ATTACHMENT III

FARLEY NUCLEAR PLANT

TECHNICAL SPECIFICATIONS CHANGE REQUEST

SPENT FUEL POOL SOLUBLE BORON CREDIT

Figure 3.7-1 Fuel Assembly Burnup Limit Requirements For All Cell Storage

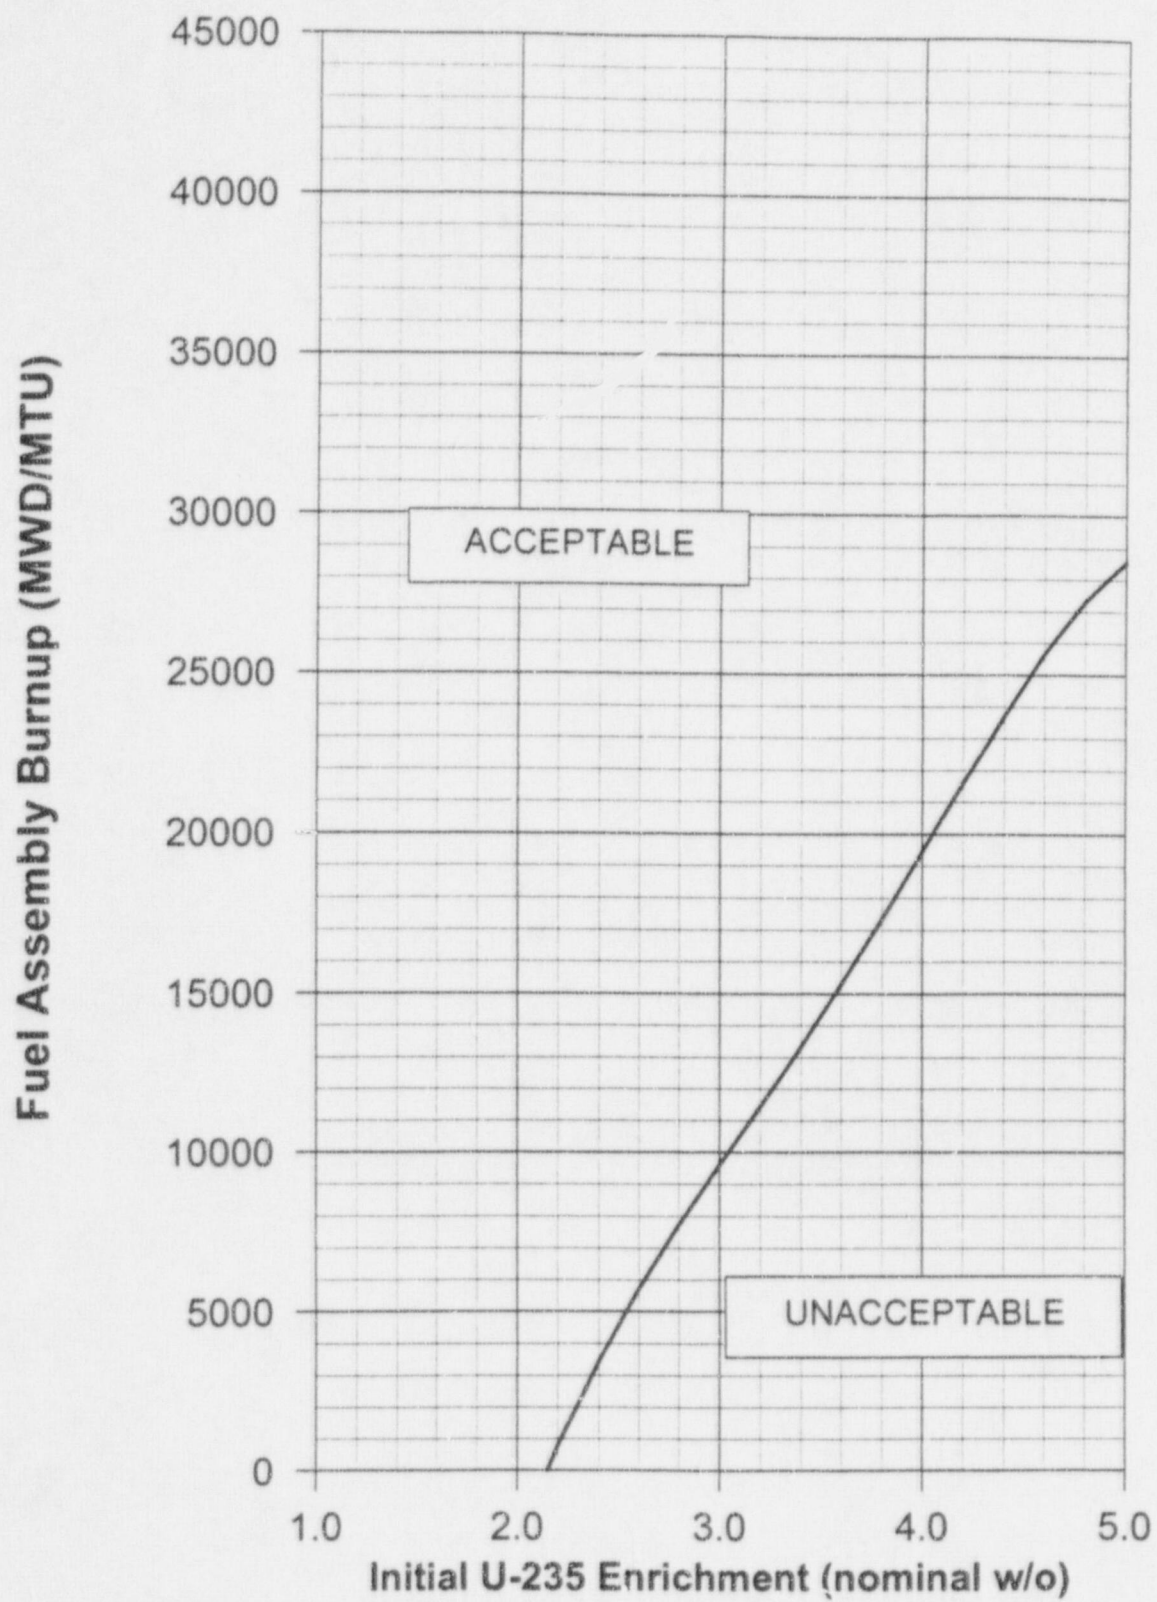
3.7.14 The combination of initial enrichment and burnup of each fuel assembly stored in the spent fuel storage pool shall be within the Acceptable Burnup Domain of Figure 3.7-1, or shall be stored in accordance with Specification 5.6.1.1.

4.7.14 The combination of initial enrichment and burnup of each fuel assembly shall be verified to be in accordance with Figure 3.7-1 or Specification 5.6.1.1 within 7 days following the relocation or addition of fuel assemblies to the spent fuel storage pool.

Figure 5.6-1 Fuel Assembly Burnup Limit Requirements for Low Enrichment (L)
Assembly of the Burned/Fresh Checkerboard Storage (see Figure 5.6-2)

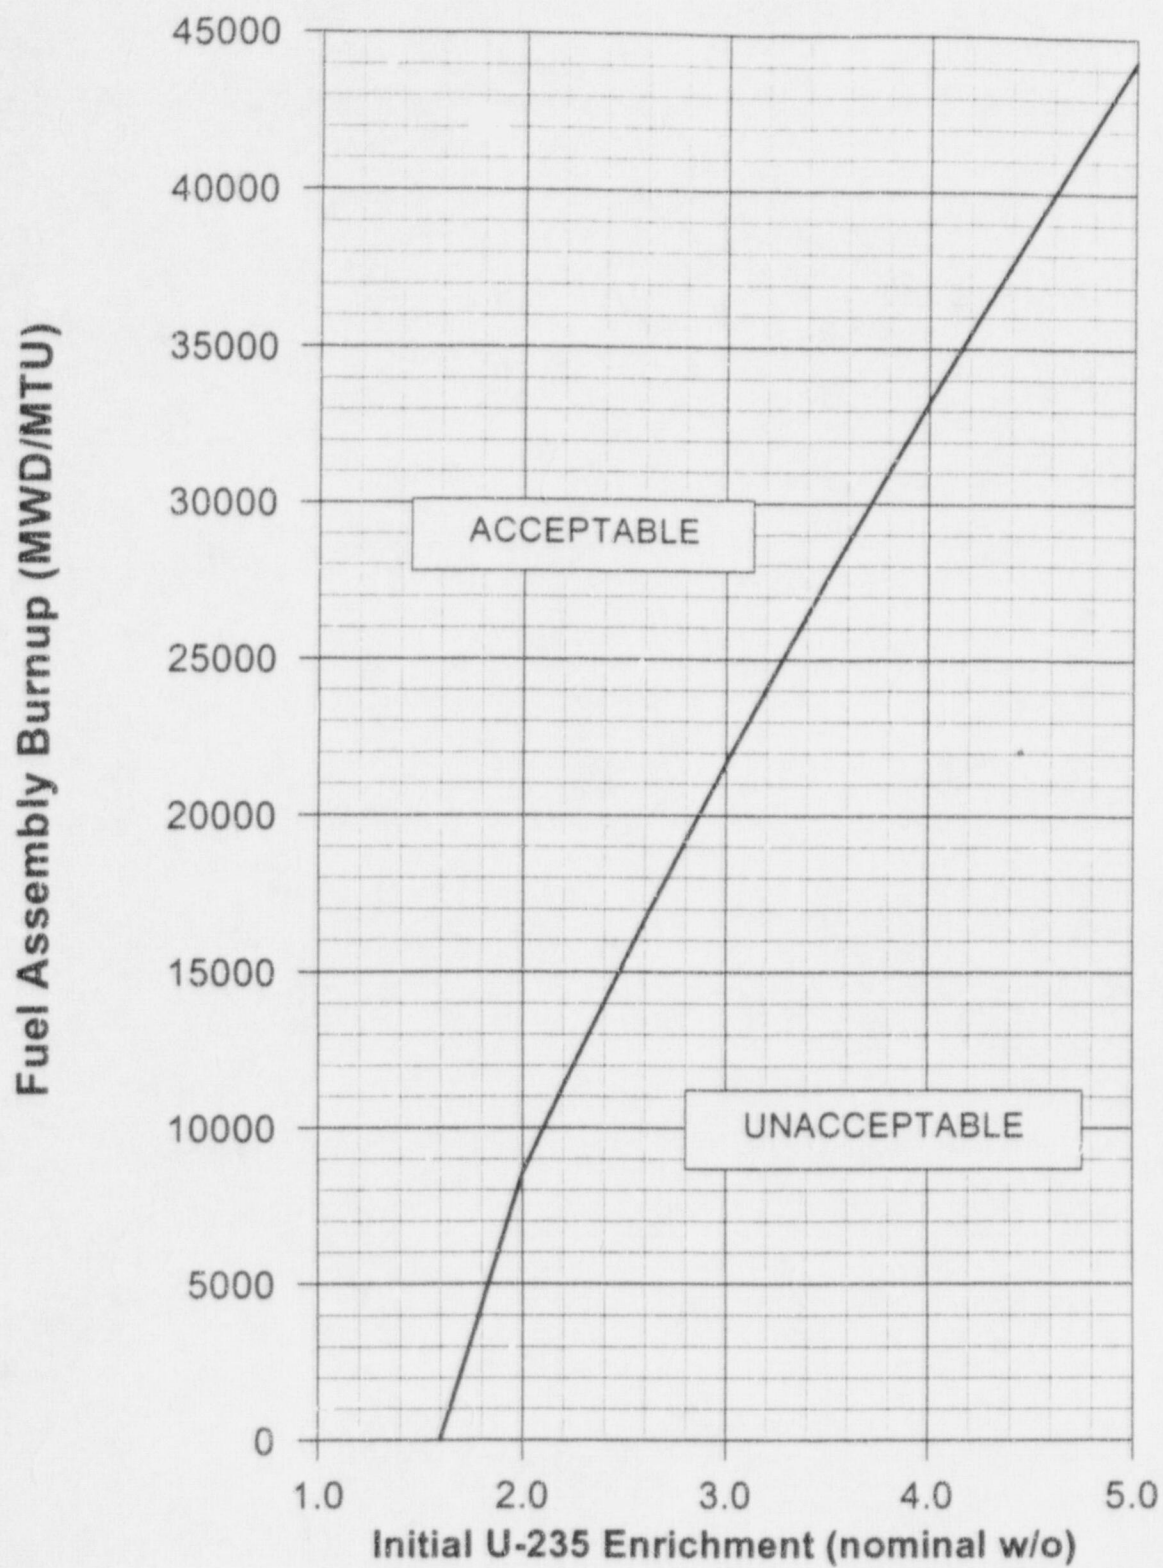
- f. New or partially spent fuel assemblies with a combination of discharge burnup and initial enrichment in the "unacceptable range" of Figure 3.7-1 will be stored in compliance with Figures 5.6-1 through 5.6-5. The high enrichment fuel assemblies shown in the Burned/Fresh Storage configuration in Figure 5.6-2, with maximum nominal enrichments greater than 3.9 w/o U-235 shall contain sufficient integral burnable absorbers such that a maximum reference fuel assembly k_{inf} less than or equal to 1.455 at 68° F is maintained.

Figure 5.6-2 Spent Fuel Storage Configurations

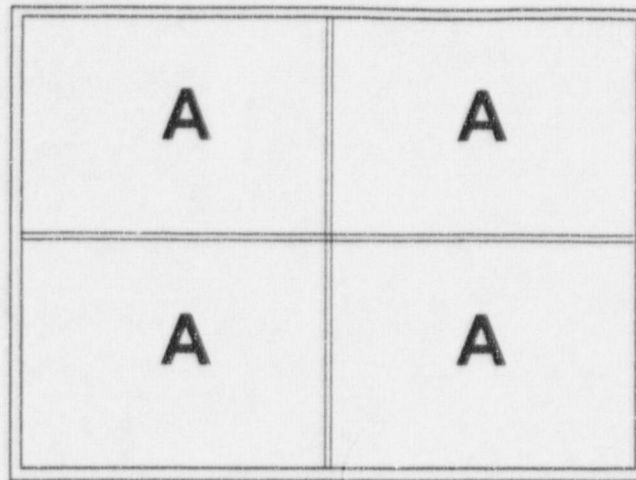
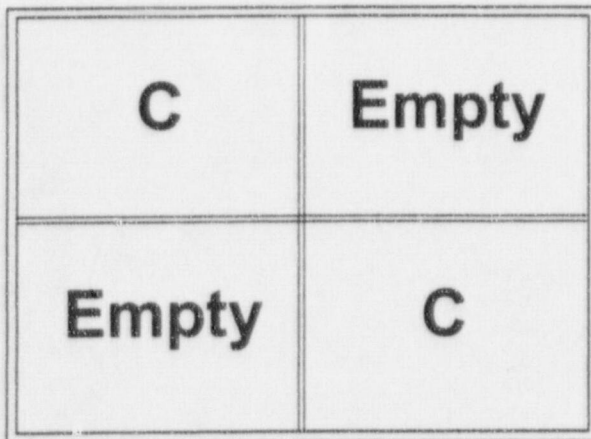
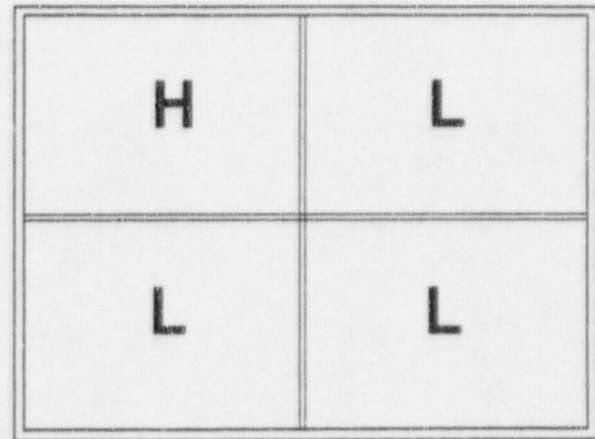
- e. New or partially spent fuel assemblies with a combination of discharge burnup and initial enrichment in the "acceptable range" of Figure 3.7-1 may be allowed unrestricted storage in the spent fuel racks (also shown as the All Cell Storage configuration in Figure 5.6-2).

Westinghouse 17X17 fuel assemblies with nominal enrichments less than or equal to 2.15 w/o U-235 can be stored in any cell location as shown in Figure 5.6-2. Fuel assemblies with initial nominal enrichments greater than these limits must satisfy a minimum burnup requirement as shown in Figure 3.7-1.

Westinghouse 17X17 fuel assemblies with nominal enrichments less than or equal to 5.0 w/o U-235 can be stored in a 2 out of 4 checkerboard arrangement as shown in Figure 5.6-2. In the 2 out of 4 checkerboard storage arrangement, 2 fuel assemblies can be stored corner adjacent with 2 empty storage cells.

Westinghouse 17X17 fuel assemblies can be stored in a burned/fresh checkerboard arrangement of a 2X2 matrix of storage cells as shown in Figure 5.6-2. In the burned/fresh 2X2 checkerboard arrangement, three of the fuel assemblies must have an initial nominal enrichment less than or equal to 1.6 w/o U-235, or satisfy a minimum burnup requirement for higher initial enrichments as shown in Figure 5.6-1. The fourth fuel assembly must have an initial nominal enrichment less than or equal to 3.9 w/o U-235, or satisfy a minimum Integral Fuel Burnable Absorber requirement for higher initial enrichments to maintain the reference fuel assembly k_{inf} less than or equal to 1.455 at 68° F.

Figure 3.7-1 Fuel Assembly Burnup Limit Requirements For All Cell Storage

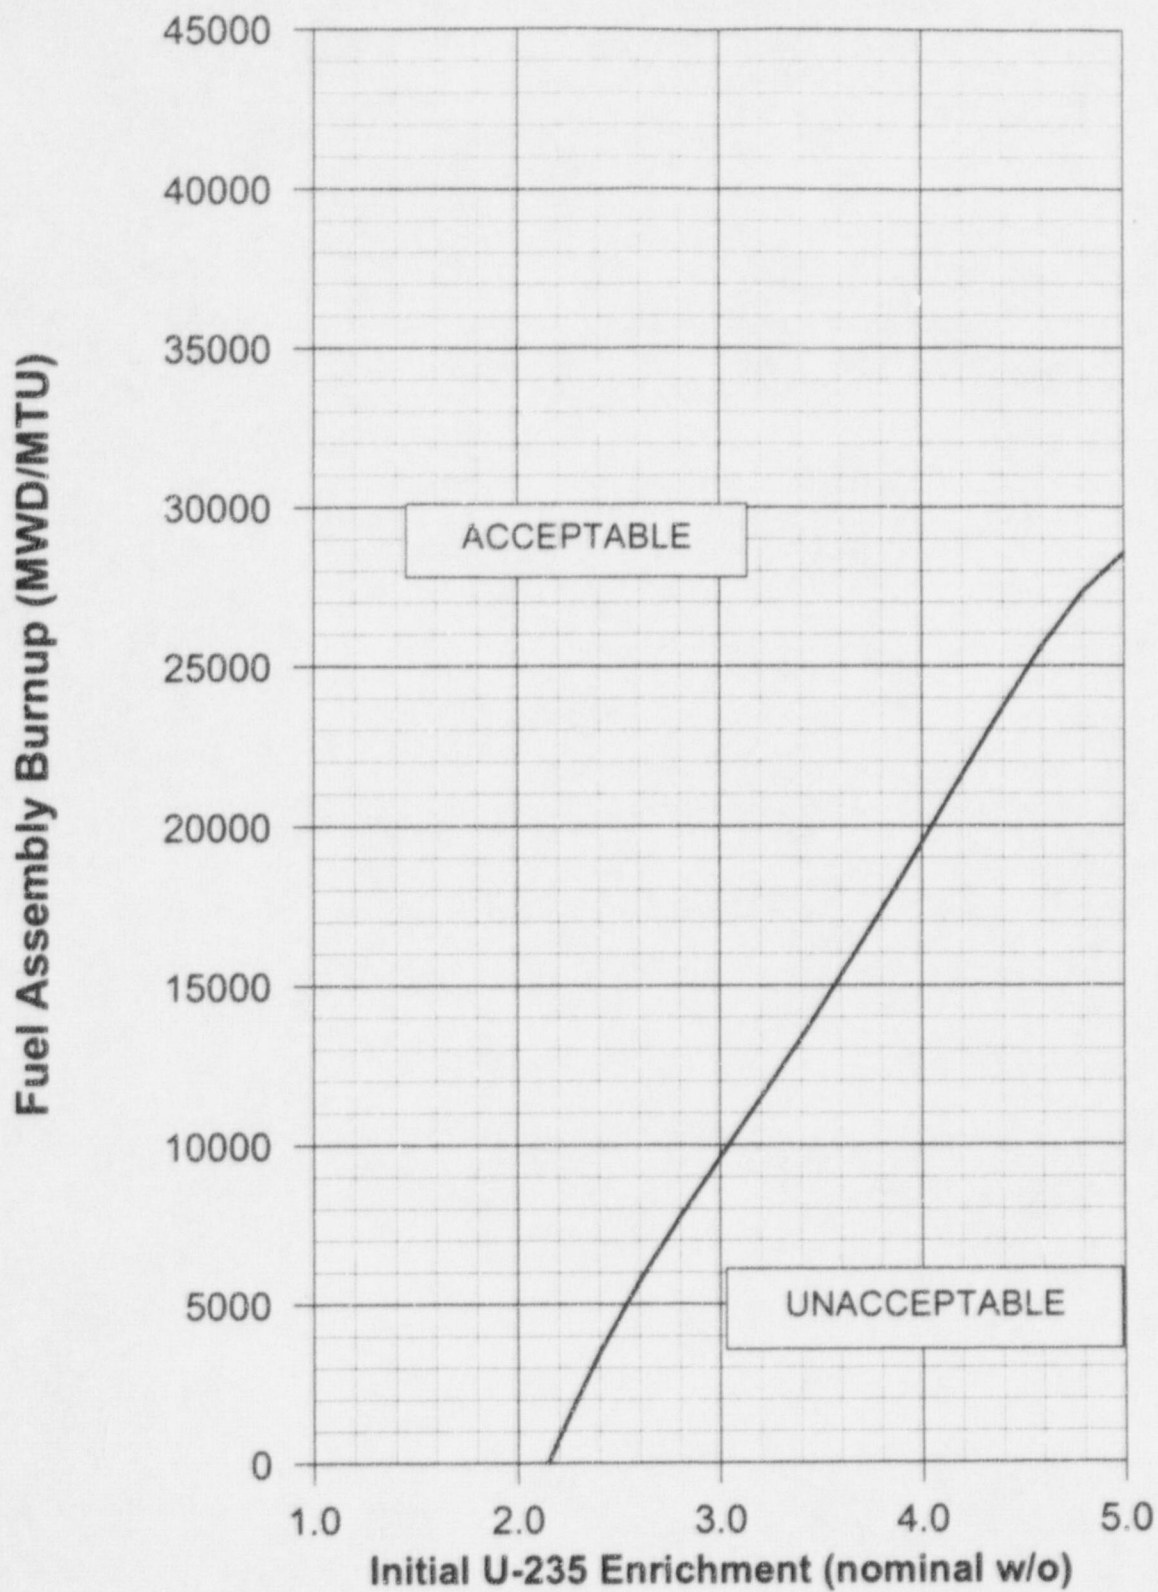
3.7.15 The combination of initial enrichment and burnup of each fuel assembly stored in the spent fuel storage pool shall be within the Acceptable Burnup Domain of Figure 3.7-1, or shall be stored in accordance with Specification 5.6.1.1.

4.7.15 The combination of initial enrichment and burnup of each fuel assembly shall be verified to be in accordance with Figure 3.7-1 or Specification 5.6.1.1 within 7 days following the relocation or addition of fuel assemblies to the spent fuel storage pool.

Figure 5.6-1 Fuel Assembly Burnup Limit Requirements for Low Enrichment (L)
Assembly of the Burned/Fresh Checkerboard Storage (see Figure 5.6-2)

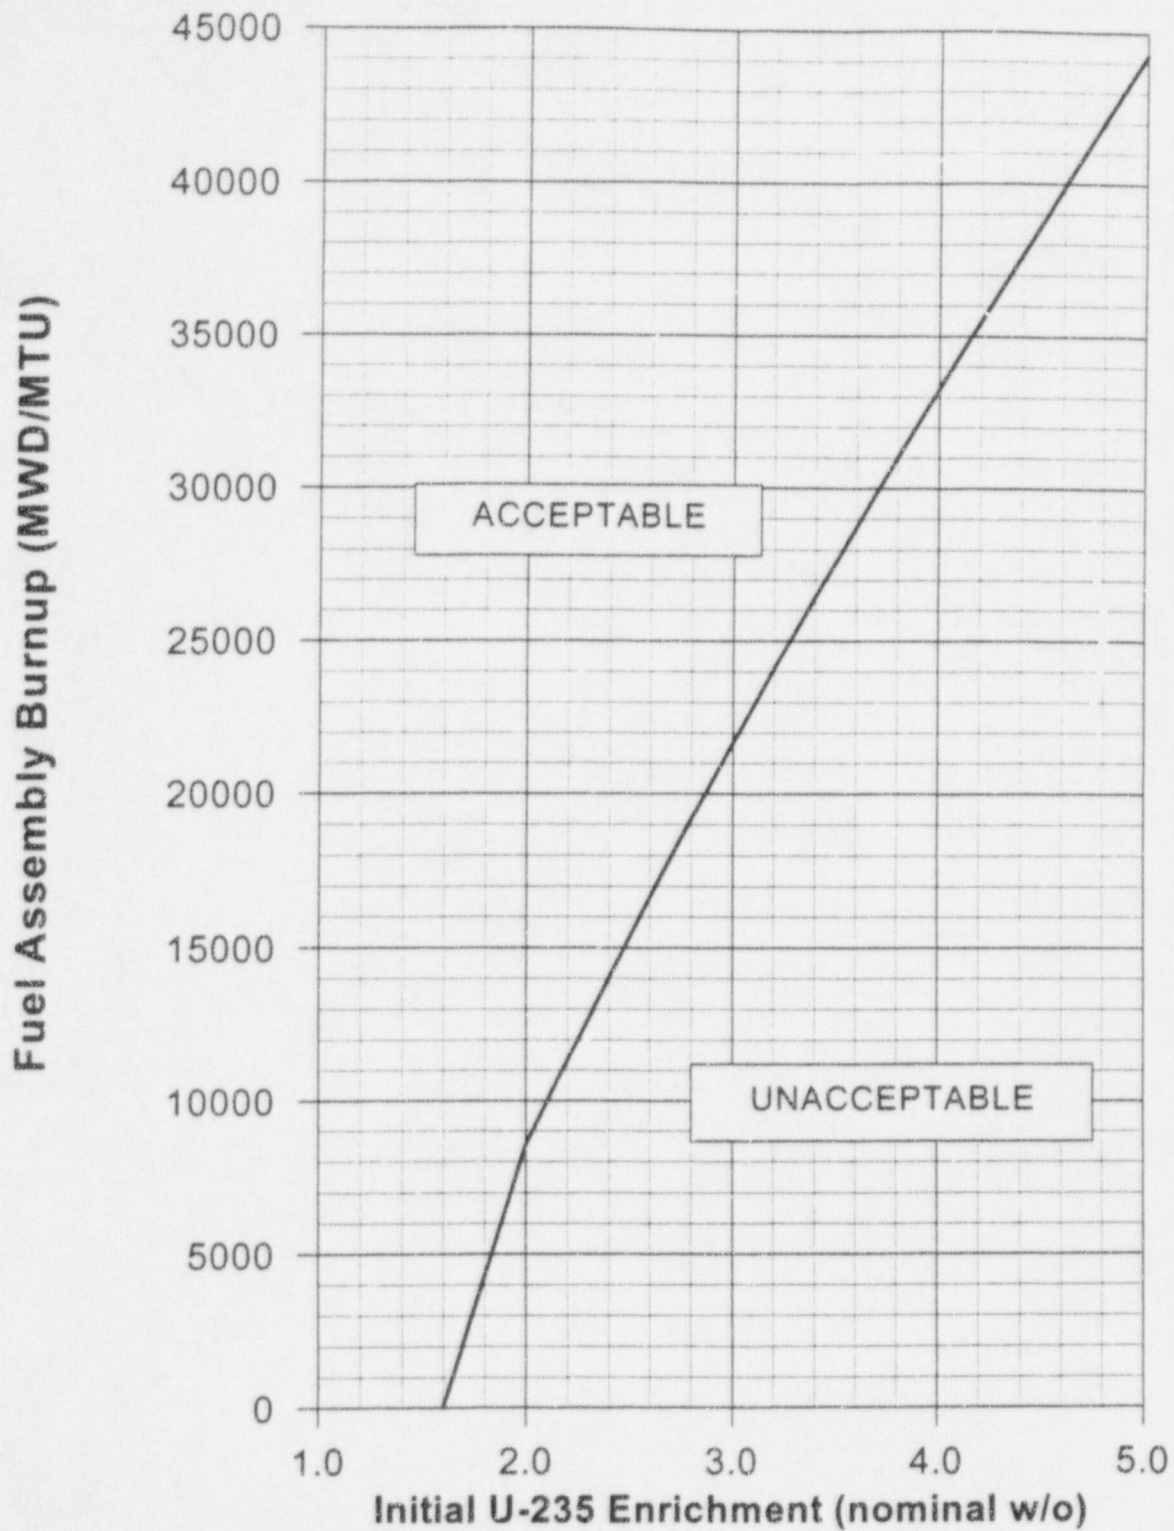
- e. New or partially spent fuel assemblies with a combination of discharge burnup and initial enrichment in the "acceptable range" of Figure 3.7-1 may be allowed unrestricted storage in the spent fuel racks (also shown as the All Cell Storage configuration in Figure 5.6-2).
- f. New or partially spent fuel assemblies with a combination of discharge burnup and initial enrichment in the "unacceptable range" of Figure 3.7-1 will be stored in compliance with Figures 5.6-1 through 5.6-5. The high enrichment fuel assemblies shown in the Burned/Fresh Storage configuration in Figure 5.6-2, with maximum nominal enrichments greater than 3.9 w/o U-235 shall contain sufficient integral burnable absorbers such that a maximum reference fuel assembly k_{∞} less than or equal to 1.455 at 68° F is maintained.

Figure 5.6-2 Spent Fuel Storage Configurations

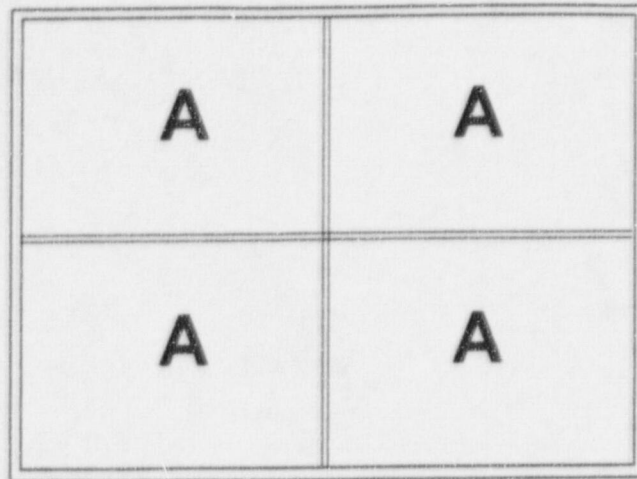
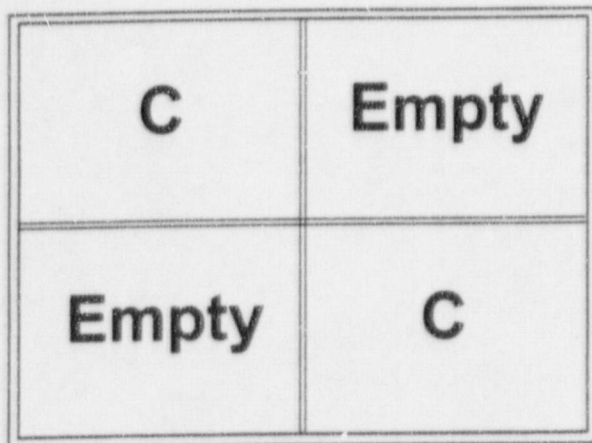
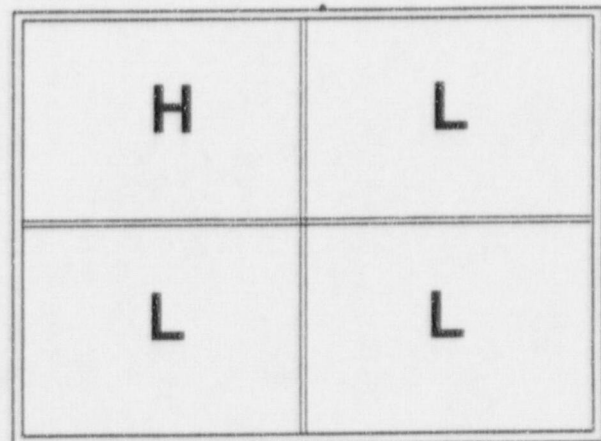
Westinghouse 17X17 fuel assemblies with nominal enrichments less than or equal to 2.15 w/o U-235 can be stored in any cell location as shown in Figure 5.6-2. Fuel assemblies with initial nominal enrichments greater than these limits must satisfy a minimum burnup requirement as shown in Figure 3.7-1.

Westinghouse 17X17 fuel assemblies with nominal enrichments less than or equal to 5.0 w/o U-235 can be stored in a 2 out of 4 checkerboard arrangement as shown in Figure 5.6-2. In the 2 out of 4 checkerboard storage arrangement, 2 fuel assemblies can be stored corner adjacent with 2 empty storage cells.

Westinghouse 17X17 fuel assemblies can be stored in a burned/fresh checkerboard arrangement of a 2X2 matrix of storage cells as shown in Figure 5.6-2. In the burned/fresh 2X2 checkerboard arrangement, three of the fuel assemblies must have an initial nominal enrichment less than or equal to 1.6 w/o U-235, or satisfy a minimum burnup requirement for higher initial enrichments as shown in Figure 5.6-1. The fourth fuel assembly must have an initial nominal enrichment less than or equal to 3.9 w/o U-235, or satisfy a minimum Integral Fuel Burnable Absorber requirement for higher initial enrichments to maintain the reference fuel assembly k_{eff} less than or equal to 1.455 at 68° F.
